**Berry-Messiter FL A93635
 Visual Impact Assessment
 and
 Leave Patch Design Recommendation
 RDI Resource Design Inc
 January 2, 2016
 Preliminary Assessment
 Cutblocks AM8MB, AM8MC, AM8T2, AM7UH**

**RDI Resource Design Inc Visual Assessment
BCTS FL A93635, Cutblocks AM8MB, AM8T2, AM8MC and AM7UH**

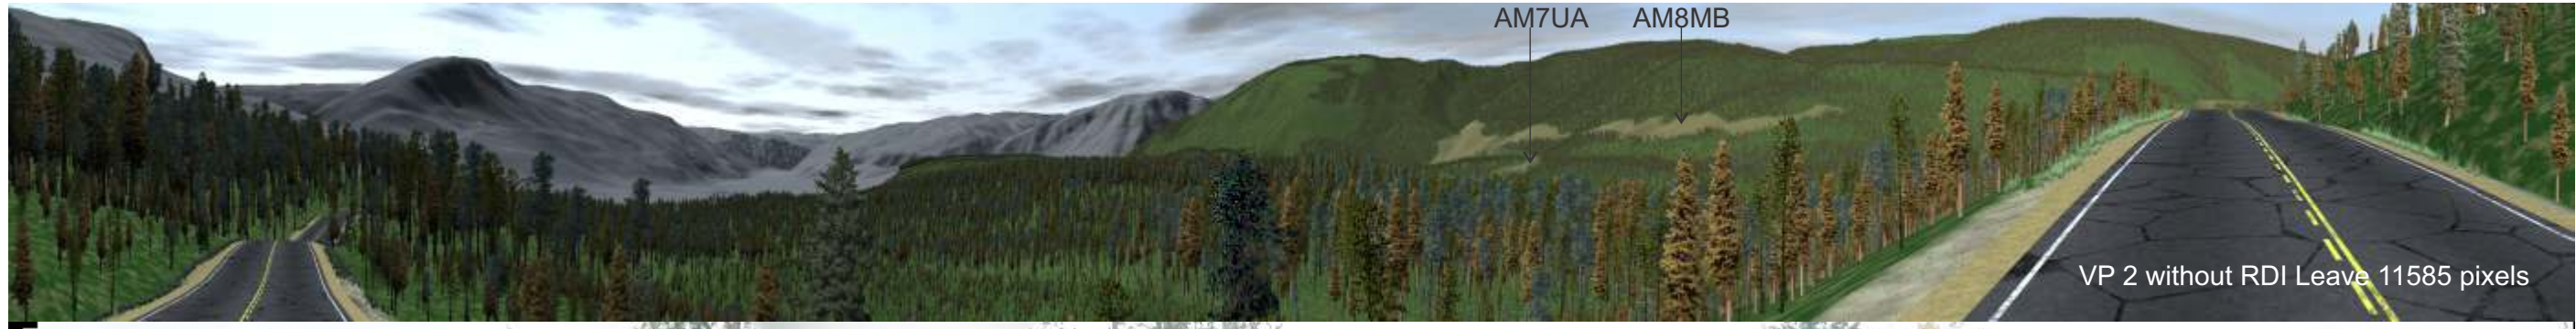
There are noticeable topographic/geologic variations within the main 892 landform, particularly the major draw leading from the height of land which cuts through the southern part of AM8MB. The design of AM8MB responds appropriately to this strong visual force by expanding upwards into the concavity. The shape of AM8MB also appears to respond adequately to the more subtle visual forces across the landform.

The block is currently segmented into two distinct parts caused by the narrowing of the gap between top and bottom, visually. RDI has recommended two small leave patches to break the overall linearity by closing (or nearly closing, as possible) the gap in AM8MB at two additional locations in the block to give the block 4 visually distinct units with visual force lines running through the breaks. The changes as currently suggested by RDI are 0.31 ha and 0.38 ha in extent. Additional closure can be quite easily achieved by expanding the leave patches downwards. Recommended design changes are subject to field feasibility.

VLI_Poly_No 892 VLI_Poly_No 894
 AM7UA AM8MB AM8T2 (AM8MC NVS)

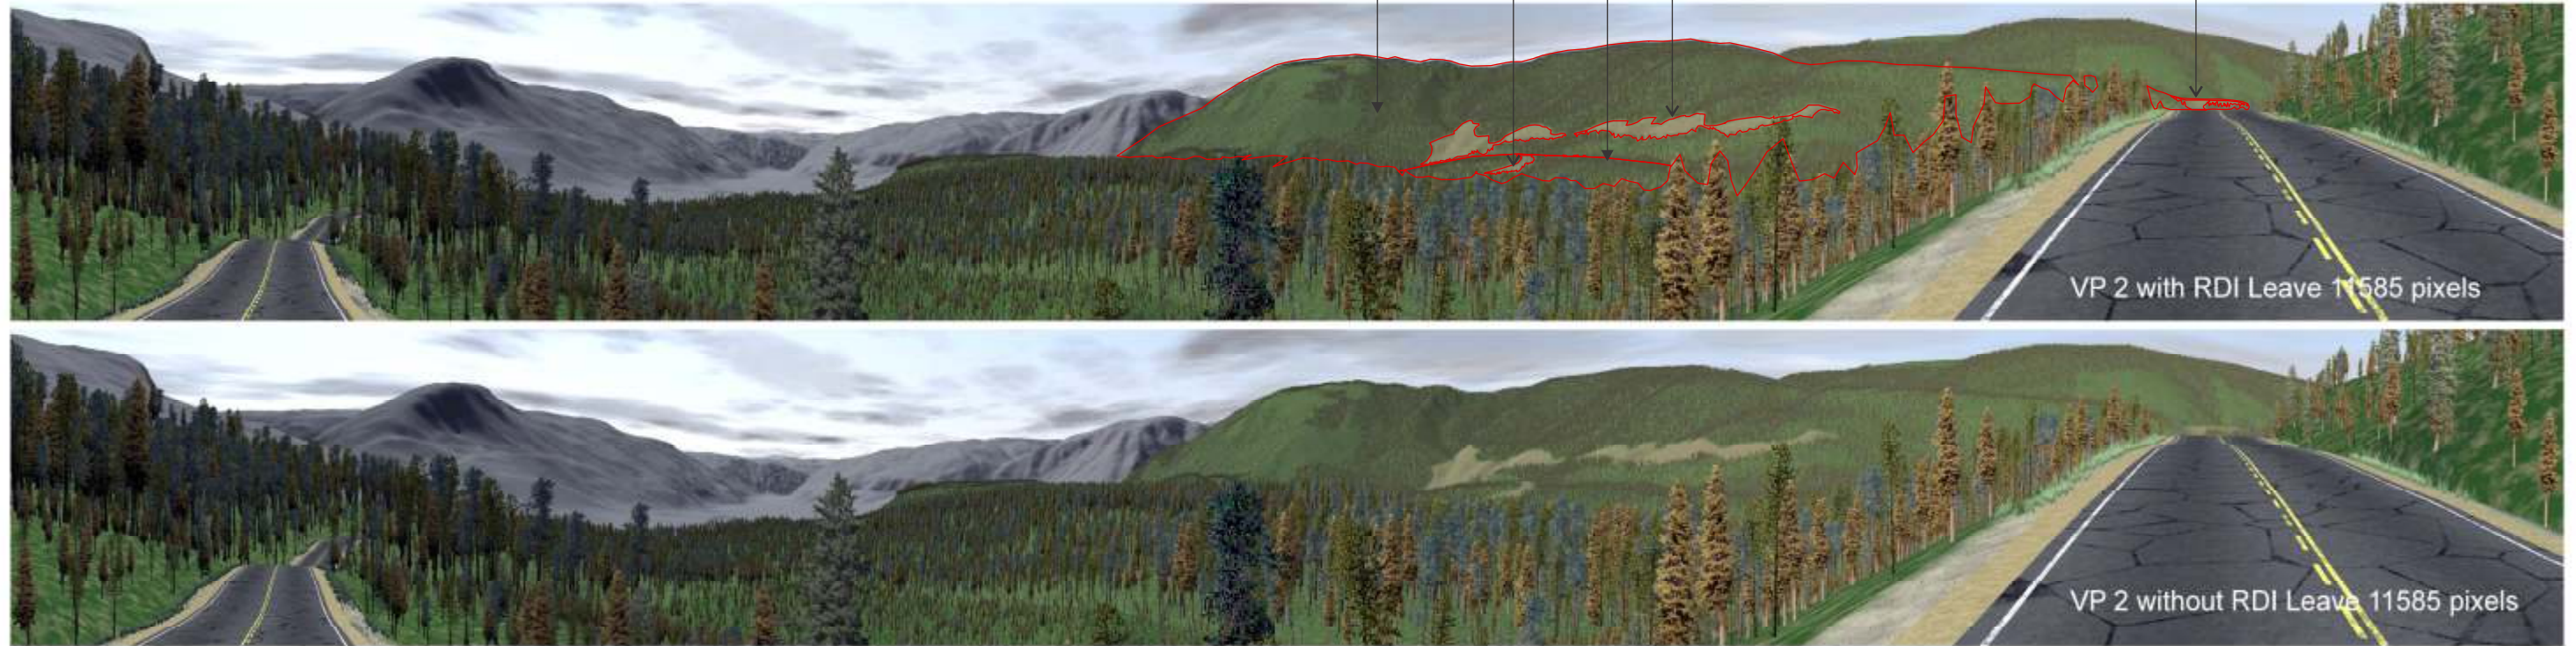
Percent alteration calculation from Viewpoint 2 near the rest-stop shows that polygon 892 will be altered by just over 6% with most attributed to AM8MB and a small amount by AM8T2. The much smaller polygon 894 by will be altered by 5% by AM7UA. Both landform will be within the PR limit of 7%.

Percent Alteration without RDI leave areas in polygon 892 will be slightly greater
